SECTION 4.55 MODIFICATION

Modification to DA/538/2019

607 Canterbury Road, Belmore

Document Type: Section 4.55 Modification Report

Drawing Title:
Proposed Car Wash Plans and Section

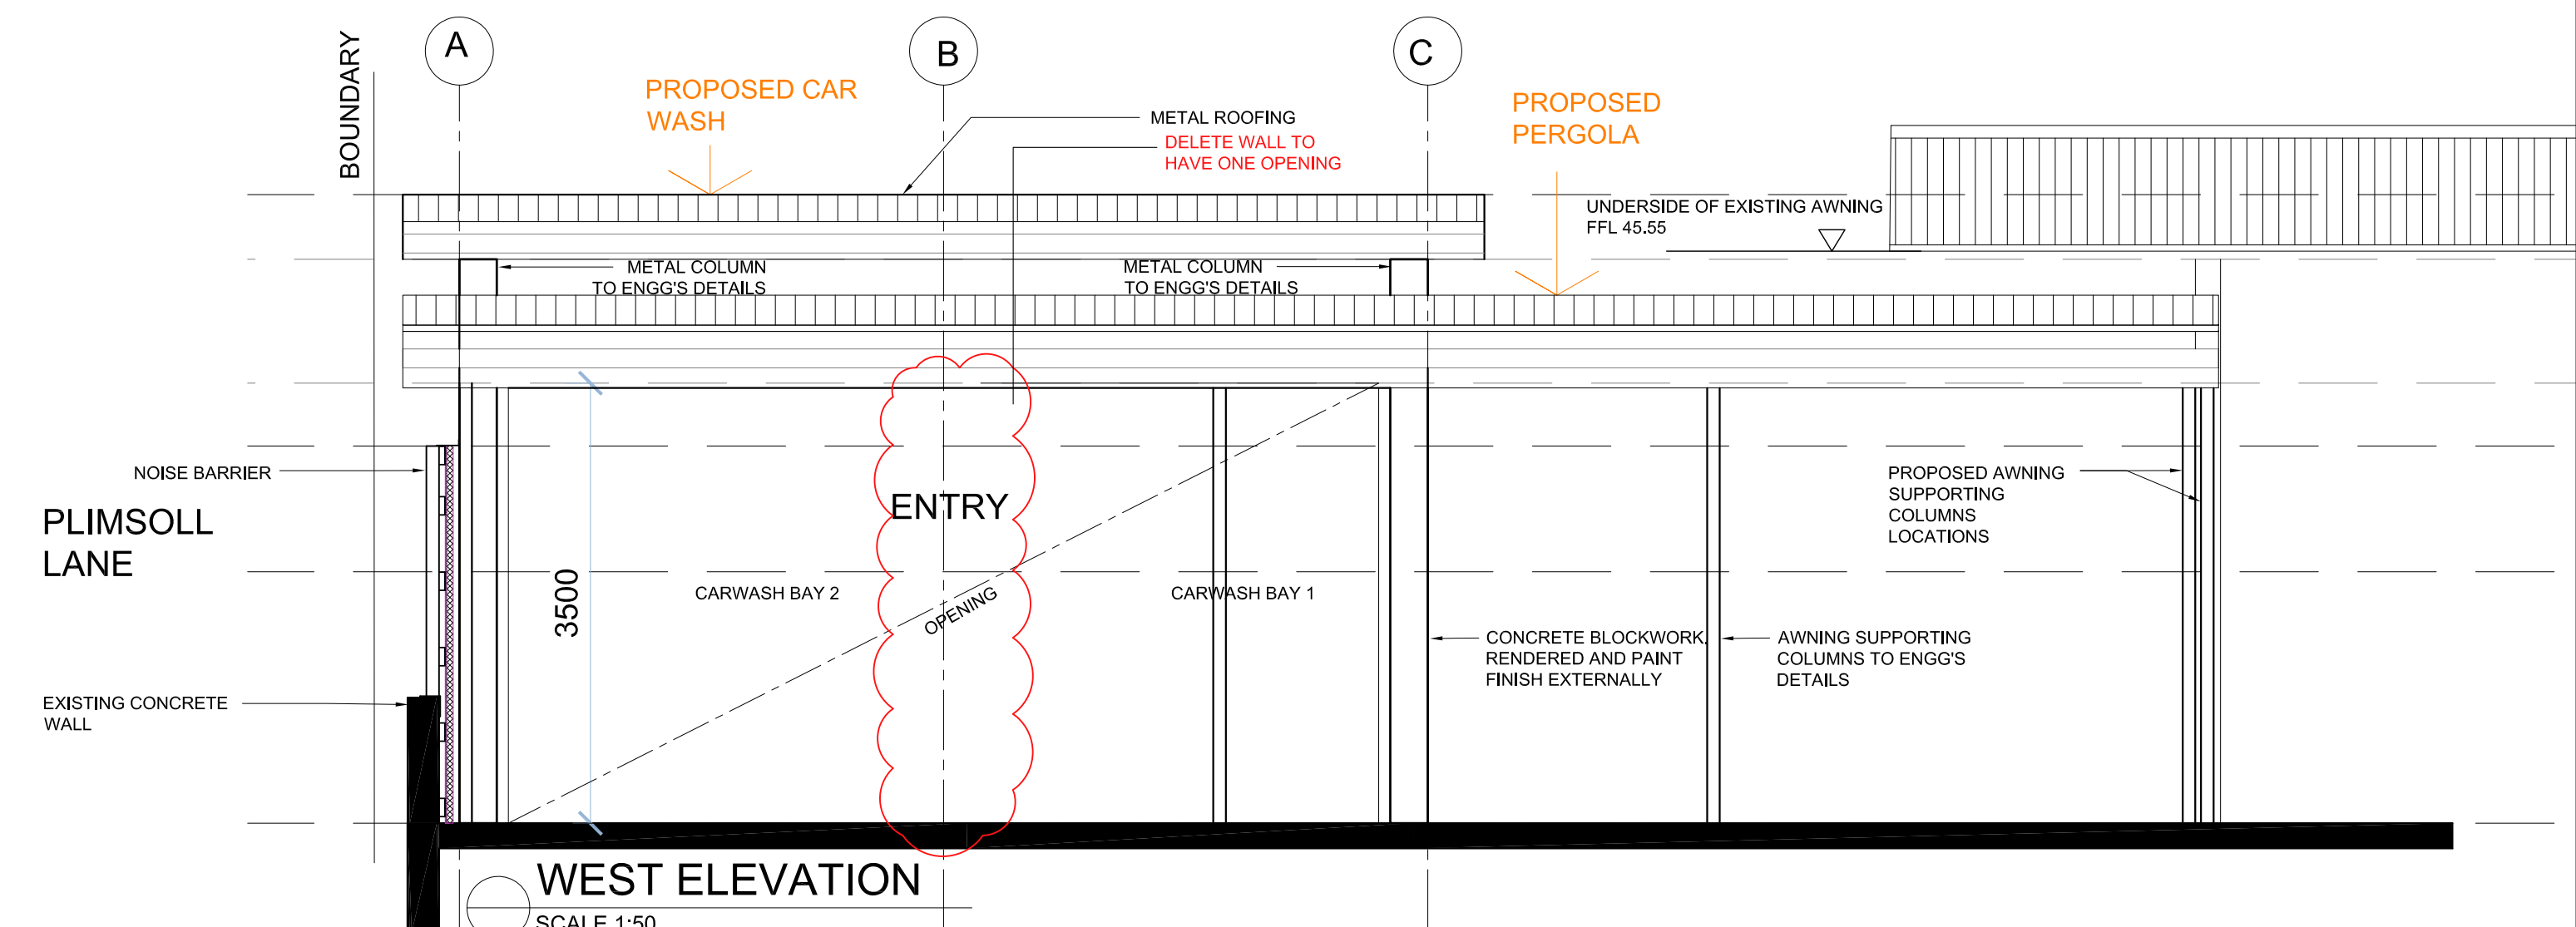
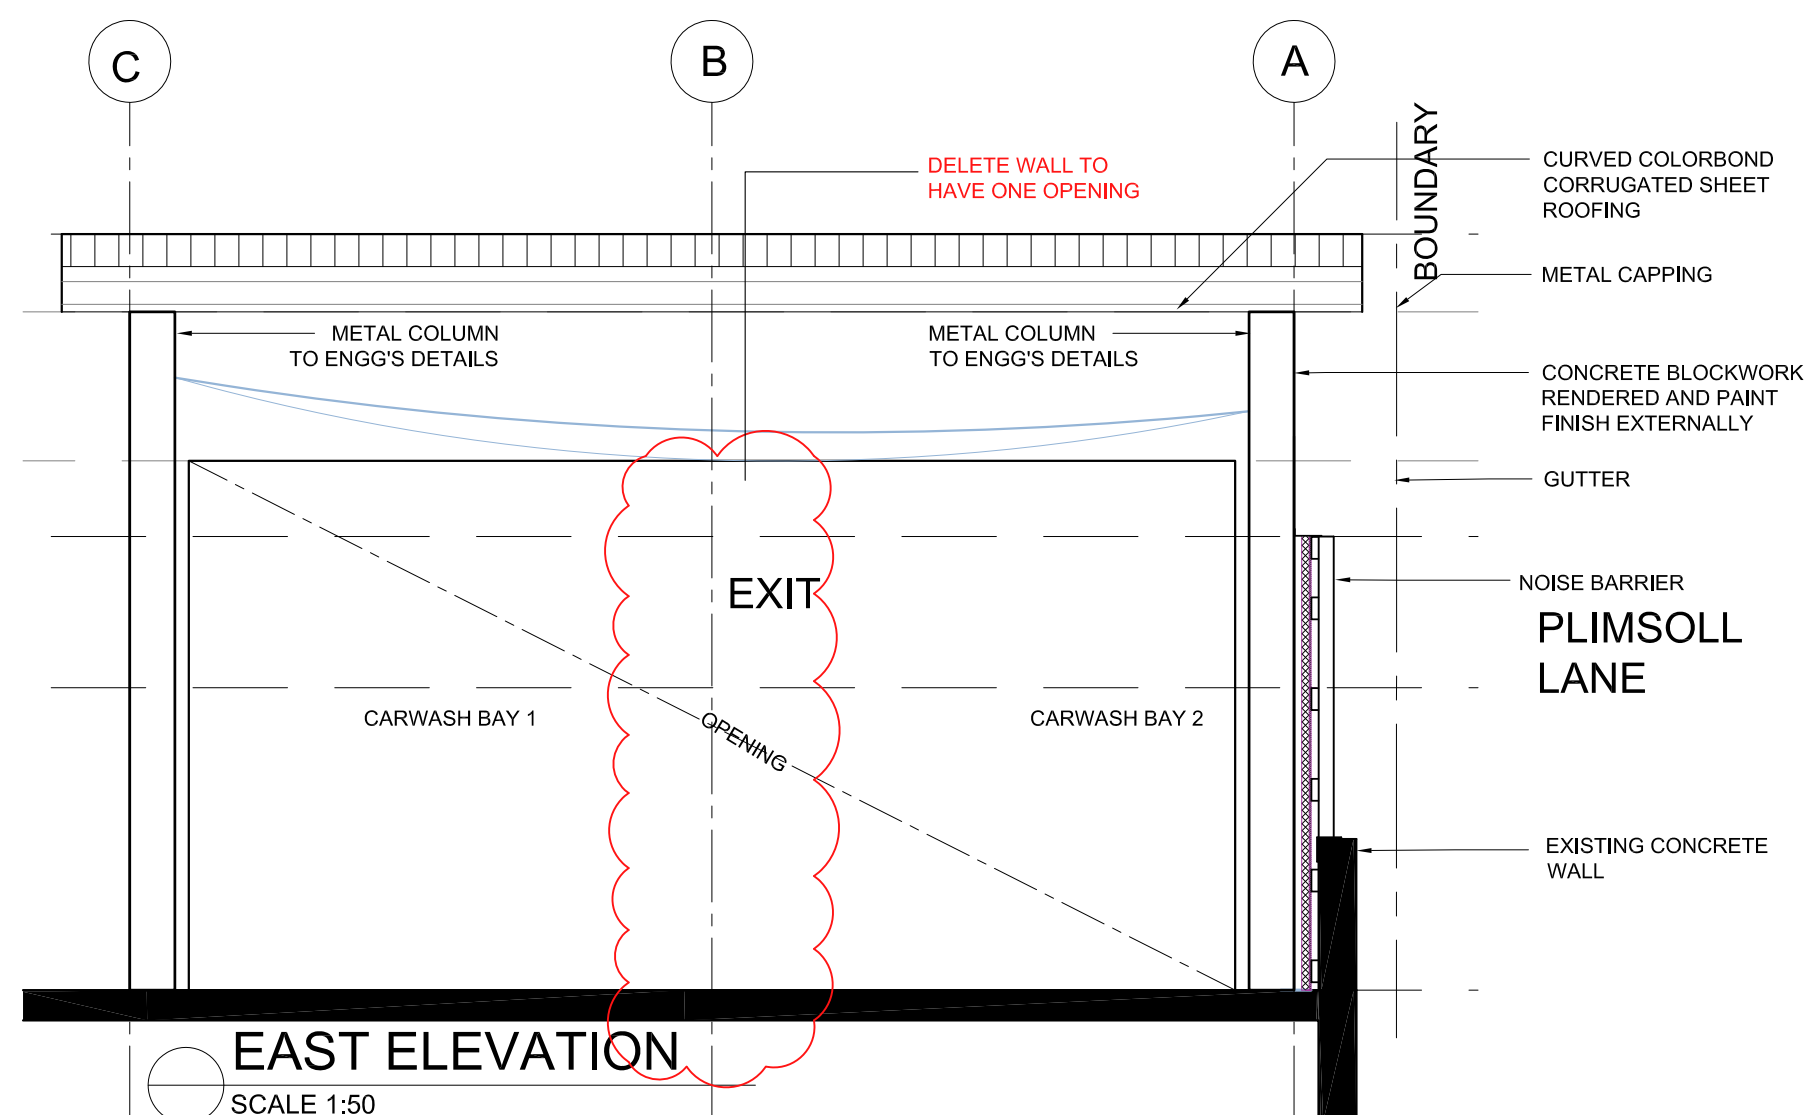
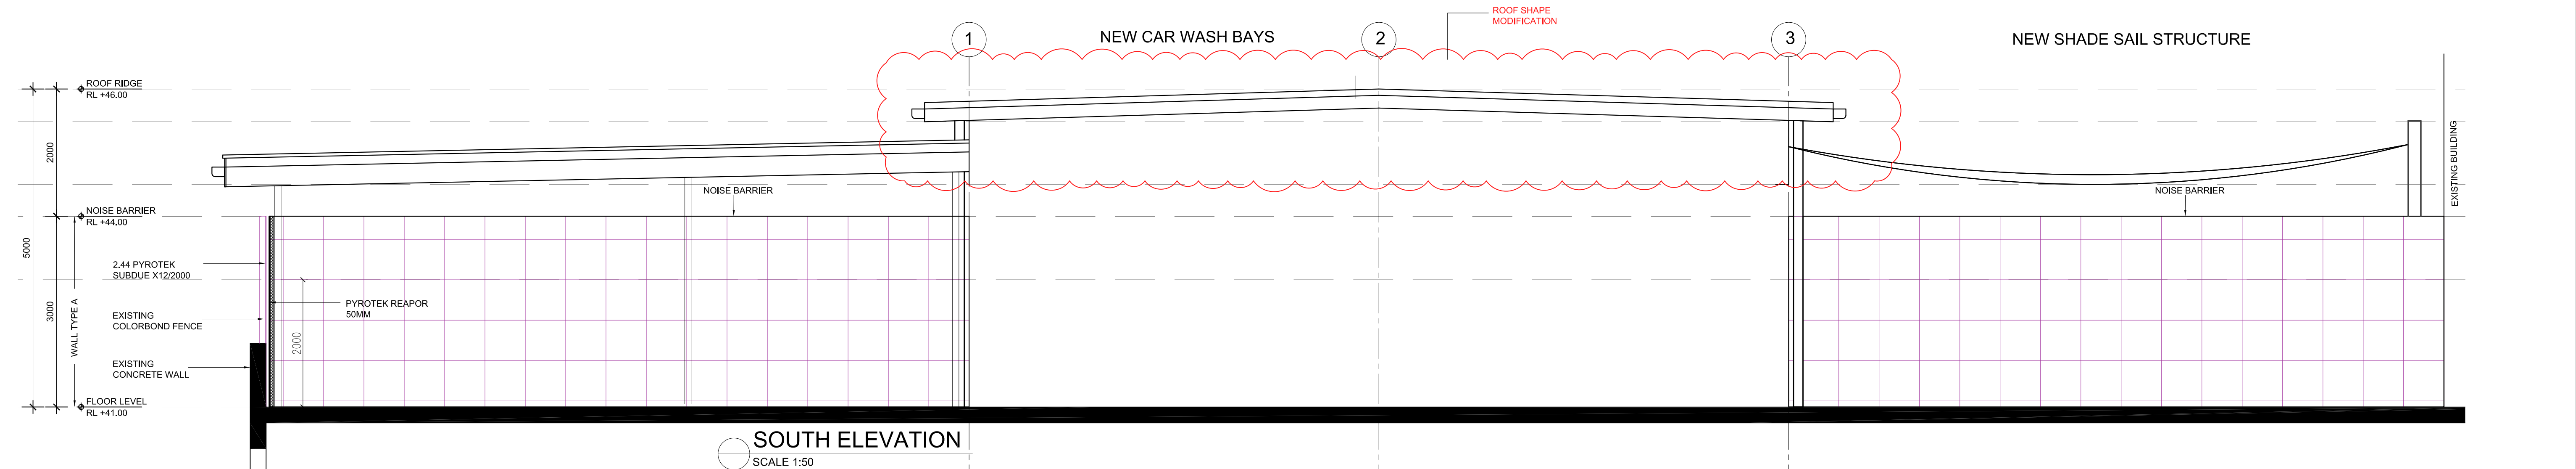
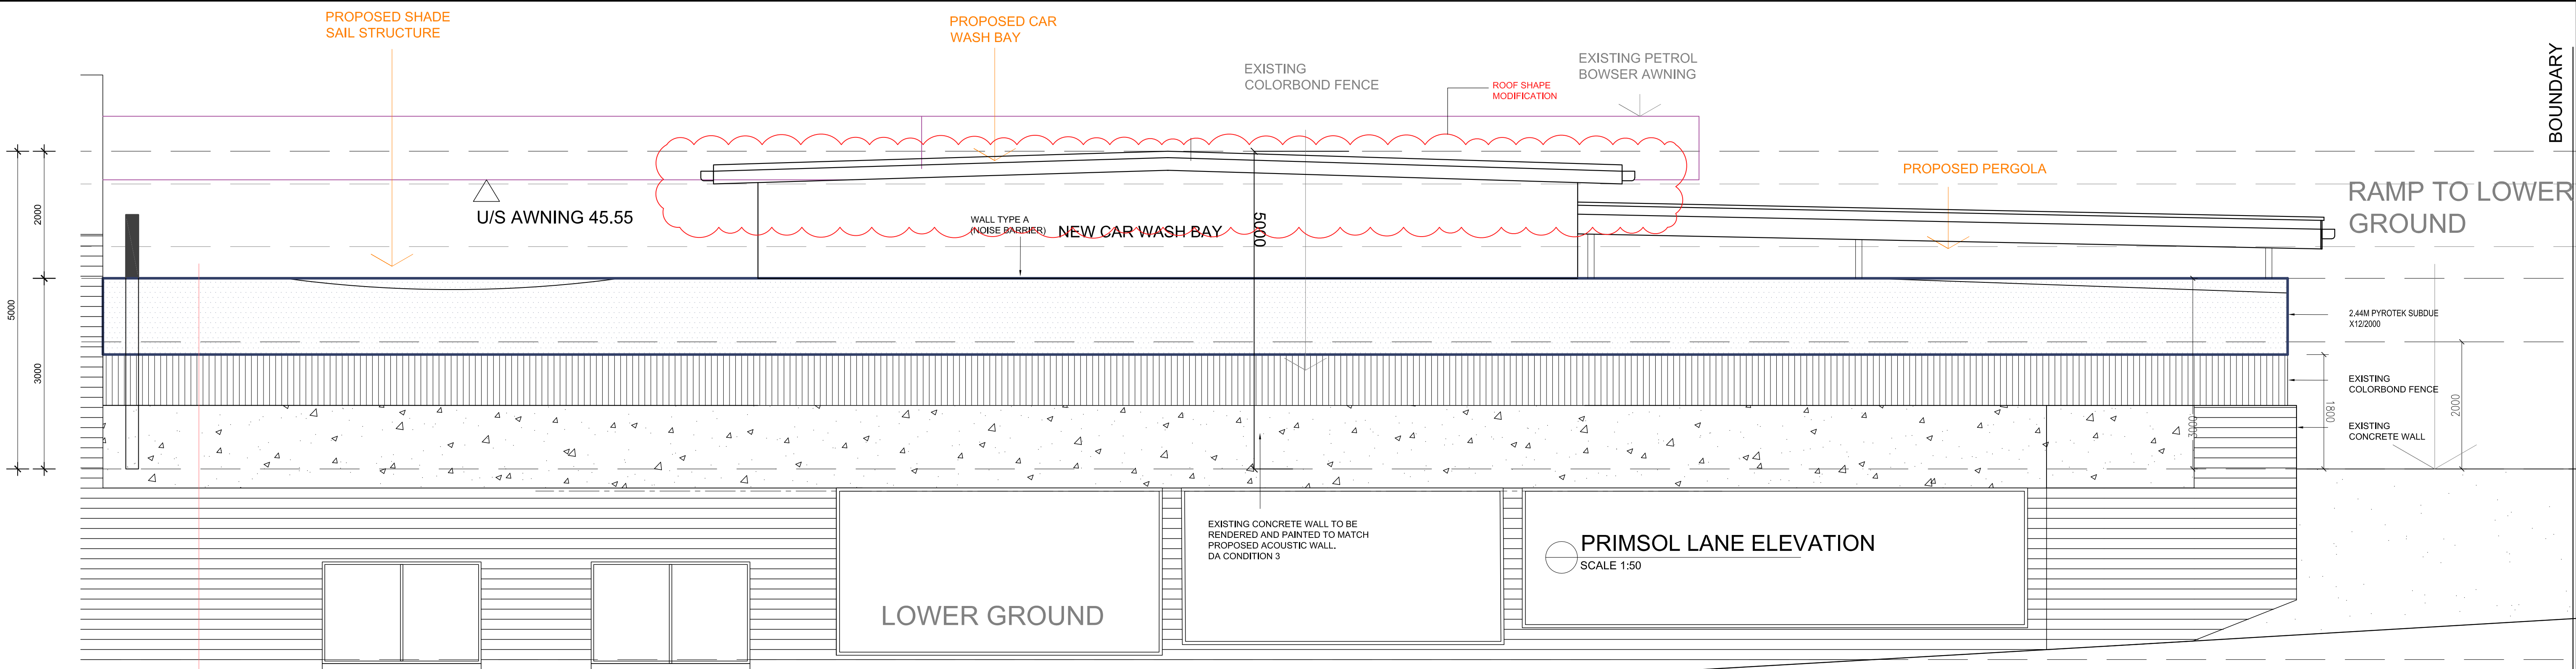
It is proposed to adopt minor modifications to the car wash bay structure. The roof shape of the car wash bay structure is to change from a curved roof shape to a pitched roof shape with a gentle roof pitch to allow rainwater to flow away from the roof.

It is also proposed to remove a central wall within the car wash structure.

LANDSCAPE
PLAN

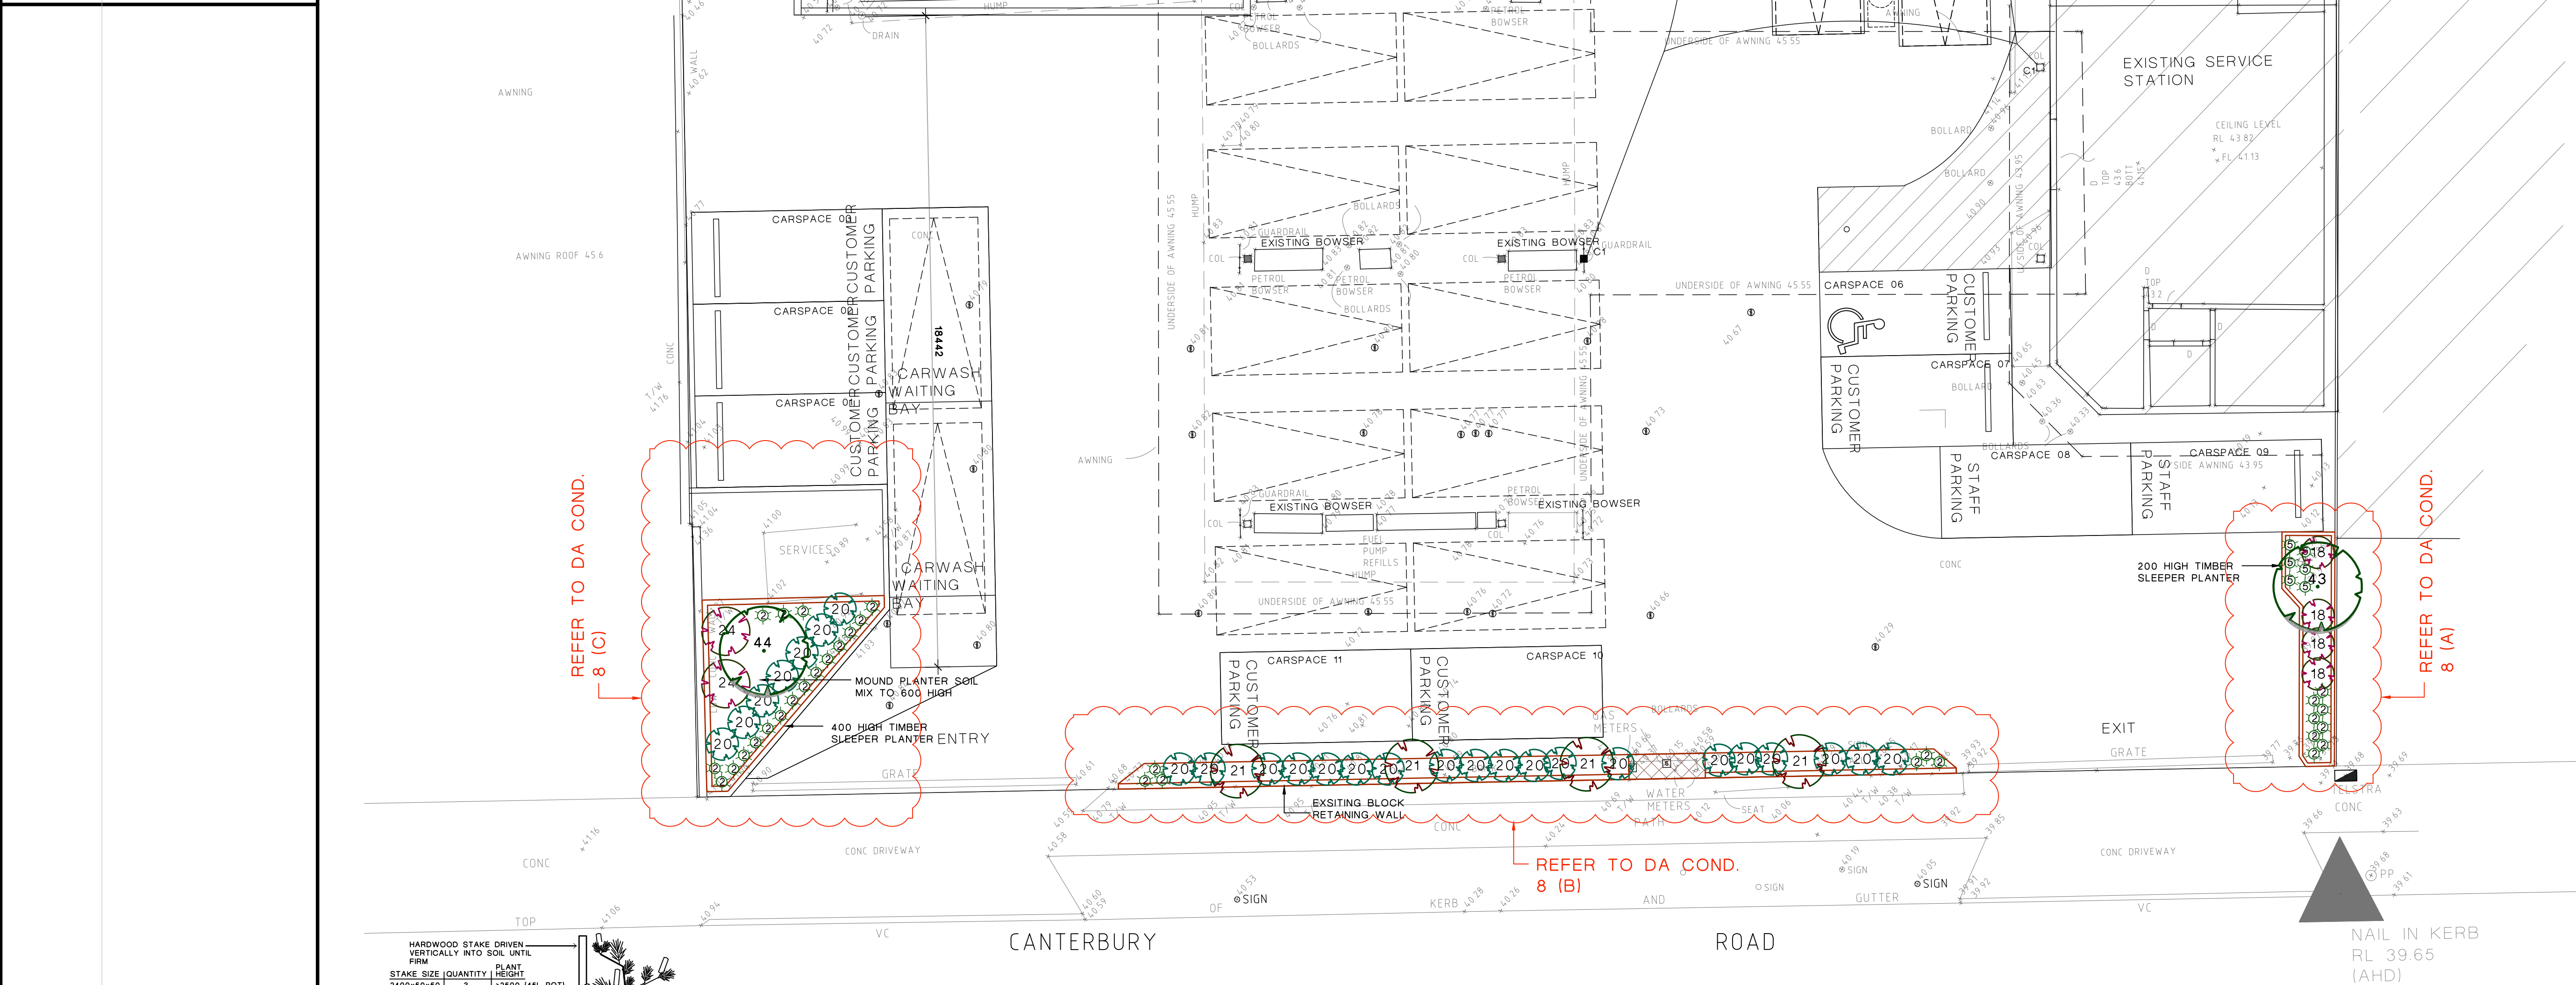
The Development Consent approved a landscape strip of 1 metre in width along the frontage to Canterbury Road. A 1 metre landscaping strip does not provide adequate width between the petrol bousers for vehicles. It is proposed to reduce the width of the landscaping strip to 0.6 metres.

The Development Consent approved deep soil zones adjacent to western boundary are constrained due to shallow depth to fuel storage tanks. It is proposed to remove landscaping from this location or require above ground planter boxes.

The amendments to the landscape design are highlighted in the modification Landscape Plan in Appendix 2.
